Dear Anonymous Referee #1:

Main concerns

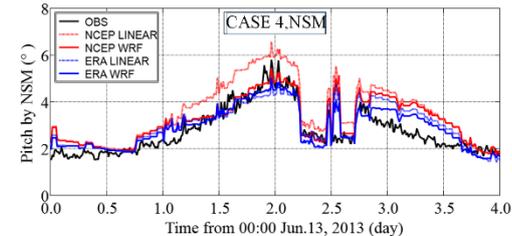
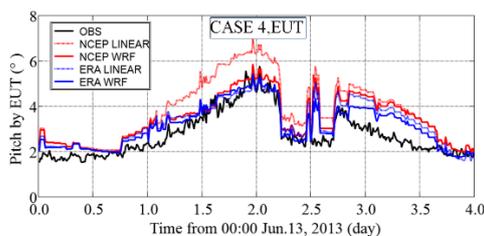
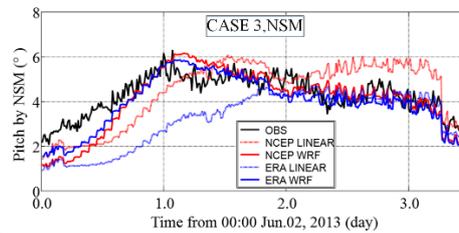
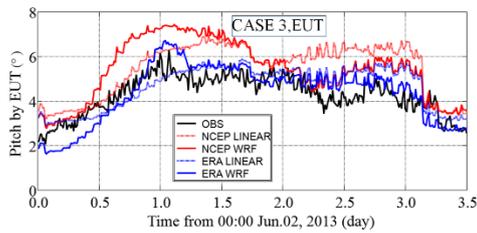
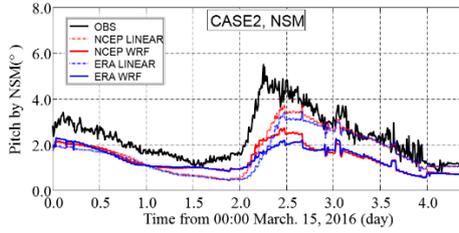
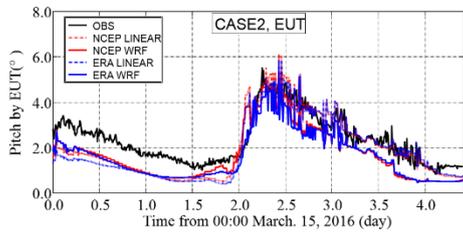
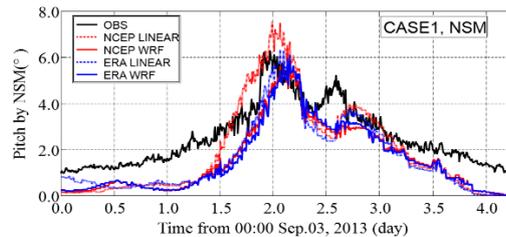
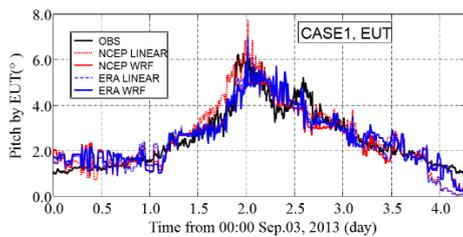
The “warning criteria” are based on a rather simple statistical analysis (essentially only studying correlations between sea state variables and ship motion responses). They seem

to be very simplistic and I wonder if not state-of-the art numerical response calculations could be used to obtain better decision support. I guess you may easily estimate the effect of the different sea state variables on ship responses by performing a set of numerical simulations using hydrodynamic models etc (for any loading condition). How does your proposed method compare with such methods and what is the benefit of doing the simple correlation analysis to suggest warning criteria. However, I believe the collected dataset is interesting, and possibly this could be used to validate such numerical models (in addition to model tests, which are commonly used to validate ship model simulations).

Regarding to your present comment, we added calculation of pitch motion by using hydrodynamic method EUT and NSM, with details shown as follows:

Among existing seakeeping models using potential theory and CFD, the enhanced unified theory (EUT; Kashiwagi, 1997) and the new strip method (NSM; Salvesen et al., 1970) were used for the calculation of the response function of pitch motion considering both the computational efficiency and accuracy, as shown in Fig. 4.

For these 4 rough sea navigation cases, EUT and NSM were used to calculate pitch motion around the maximum pitch amplitude period for four different of wave modeling results: NCEP LINEAR, NCEP WRF, ERA LINEAR, and ERA WRF (shown as following figures).

Limitations of hydrodynamic models based on potential theory on the non-linearity can be seen from the differences among observation and calculations, thus, as a complement, we tried another way by using the direct statistical data analysis (*Data, Information, Knowledge, and Wisdom*) between sea state variables and ship motion responses.

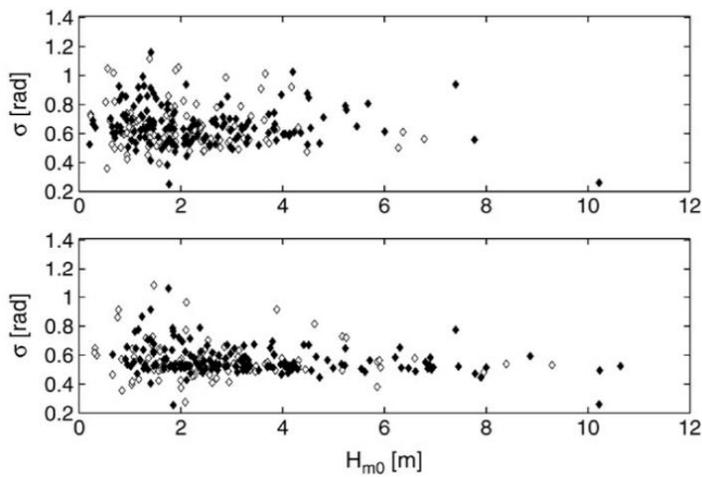
You study the correlation between sea state variables and ship response variables, and this is a major part of the paper. The times series are obviously highly autocorrelated. It is well known that strong serial correlation may give cross-correlated time-series even for independent variables, so the correlation coefficients given in Fig 6 should be interpreted with care. A note could be included on this (perhaps with reference). Moreover, what insight do you really get from all the correlations you find for the sea-states and ship response variables in sections 5.2/5.3? On p. 13 you state that the ocean waves will have a larger influence on ship motions in ballast conditions.

How can you conclude on that from higher correlation between roll and pitch?

Reference has also been added in Sec.5.1 as:

Similarly, (Toffoli et al., 2005) also found that the reduction of spreading was observed to occur during growing sea state conditions for approximately 60% of the selected cases in his study on global ship accident analysis, as shown in Fig.7. And according to his results, the magnitude of the mean directional spread was found to decrease towards a value of 0.5 (approximately 25 degree, as shown in the top-left panel in Fig.6) with an enhancement of significant wave height, which also agree with our present study.
